From: [David Conway](#)
To: [Heckington Fen Solar](#)
Cc: [Conway, David](#)
Subject: NGET response to The Examining Authority's written questions and requests for information (ExQ1)
Date: 07 November 2023 14:20:59
Attachments: [REDACTED]

Application by Ecotricity (Heck Fen Solar) Limited
Heckington Fen Solar Park

The Examining Authority's written questions and requests for information (ExQ1) Issued on 17 October 2023

Figure: Bicker Fen Substation Overview
Title: Appendix 4 - Examining Authority Questions - BIO 1.2 ii Deadline 2

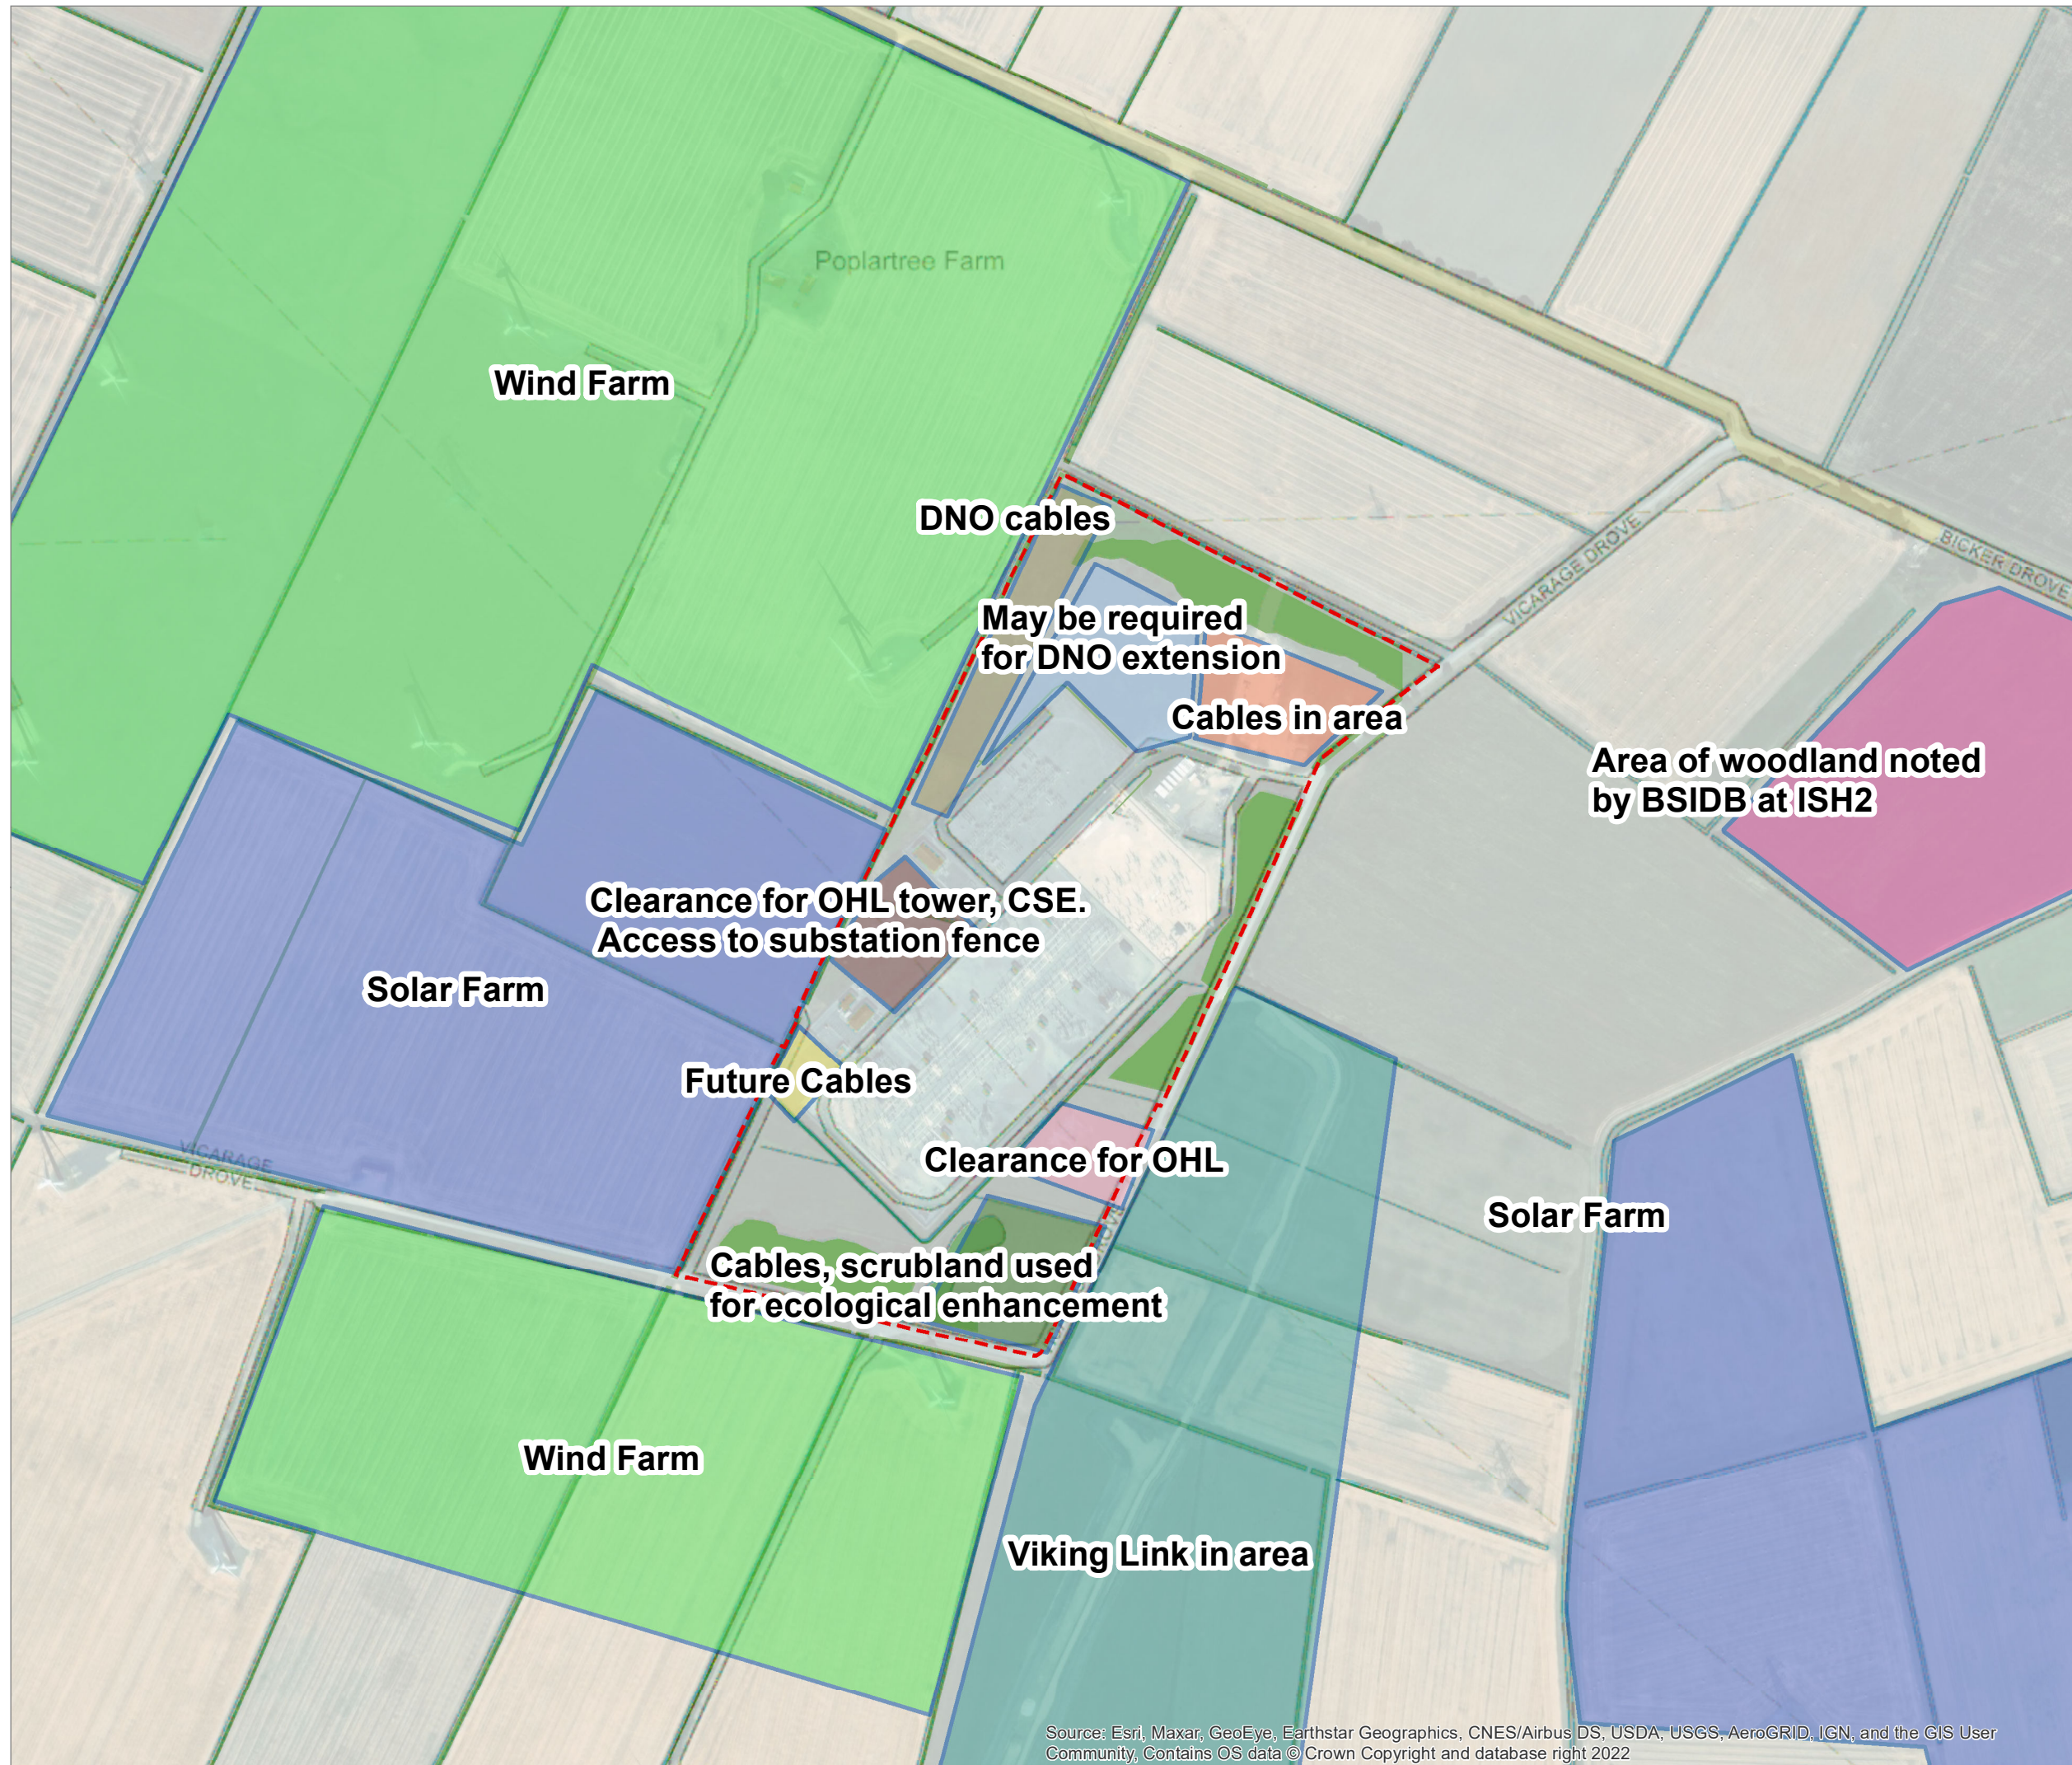
| ExQ1 | Question to: | Question: | Answers: |
|--|--|--|---|
| BIO.1.2 | Applicant National Grid Electricity Transmission Plc | <p>The Landscape Strategy Plan [PS-091] details landscaping proposals for the energy park site only and not the Bicker Fen substation. The accepted Change Application shows an area of mixed species plantation is proposed to be removed to enable additional substation infrastructure. This is further considered in the Change Application documents [PS-003 onward] which state that '<i>replacement tree planting has not been possible at Bicker Fen substation due to technical constraints and limited land availability</i>'. At Issue Specific Hearing 2 (ISH2) [REP1-020] it was indicated that there are numerous constraints to planting including location of cables.</p> <p>Could the Applicant and National Grid Electricity Transmission Plc (NGET):</p> <ul style="list-style-type: none"> i) Provide further details/plans on the extent of loss of mixed species plantation woodland to be removed to the south-west corner of Bicker Fen substation, with an indication of minimum and maximum area of loss for a) a GIS system and b) an Air Insulated Switchgear (AIS) system. ii) Provide a more detailed explanation as to why planting around the Bicker Fen substation is not appropriate | <ul style="list-style-type: none"> i) Appendix 8.13- Further Extended Phase 1 Habitat Survey Report- Bicker Fen Substation (document reference Pre-ExA.ChangeApp.ESAPP8.13.V1/ PS-153) contains details of the mixed species plantation and the percentage loss of each type of tree. It is not possible at this stage, and prior to detailed design being undertaken, to indicate a minimum area of loss but as a comparison we have indicated the areas of loss for a GIS system and an AIS system as requested. <p>A maximum footprint for the Gas Insulated Switchgear will be approximately 5,625m² (e.g., 75m by 75m). Some Switchgear apparatus will be housed indoors in a building 30m by 20m, and 15m in height. All of the infrastructure for the Gas Insulated Switchgear option will be in the footprint of Work No.6A and Work No.6B as shown on the Works Plan (document reference 2.2 / PS-014).</p> <p>The Air Insulation Switchgear will be approximately 14112m², and 15m in height. All of the infrastructure for the Air Insulated Switchgear option will be in the footprint of Work No.6A and Work No.6B as shown on the Works Plan (document reference 2.2 / PS-014).</p> <ul style="list-style-type: none"> ii) Consideration has been given to providing additional planting within NGET land. However, the substation site already has a planting plan imposed as part of a landscape condition for the original substation (Boston Borough Council application reference 05/0046). This accounts for woodland and tree planting to the north and western boundaries, and a wetland area to the south eastern corner. The remaining land is |

| ExQ1 | Question to: | Question: | Answers: |
|------|--------------|--|---|
| | | <p>and has not been included in the plans.</p> <p>iii) Give further consideration as to whether off-site planting in the vicinity of the substation (or a contribution to third party planting) has been considered, which potentially could be secured via legal agreement.</p> | <p>either constrained by existing infrastructure (e.g. pylons, cables) or is required for further development in the future and therefore should not be further constrained limiting the ability for other customers to connect to this site in the future. This statement is supplemented with a plan at Appendix 4 of this document.</p> <p>iii) The Applicant confirms consideration continues to be given to a number of options to satisfy Boston Borough Council's concerns that the replacement tree planting being provided on the Energy Park is not adequate because it is not within BBC's area.</p> <p>These include planting along the southern boundary of National Grid Bicker Fen Substation in the highway verge. This would need to be agreed with Lincolnshire County Council highways. This area is not large enough to replicate the total area of planting loss at National Grid Bicker Fen Substation and has not been progressed to date although this remains possible if agreement can be reached that it would satisfy BBC (which to date they have indicated it would not).</p> <p>The land noted by Black Sluice Internal Drainage Board at Issue Specific Hearing 2 on the 20th September 2023 for potential plantation is already underway and the trees will be funded by a grant, as such this cannot be progressed and a contribution to help maintain the new woodland is not likely satisfy BBC's requirements.</p> <p>A further option is a designated tree planting charity, for example Boston Woods Trust. The Trust confirms they only plant trees close to Boston, and when they have sufficient</p> |

| ExQ1 | Question to: | Question: | Answers: |
|-------------------------------------|--|---|---|
| | | | <p>land available to them. BBC consider that this location is too far away to be associated with the loss of trees at National Grid Bicker Fen Substation.</p> <p>The Applicant continues to explore options to satisfy the request of Boston Borough Council but would reiterate that planting is included in the Energy Park within a separate woodland parcel and within hedgerows on the northern boundary which will replace the tree loss at the Bicker Fen Substation when considering the project as a whole.</p> |
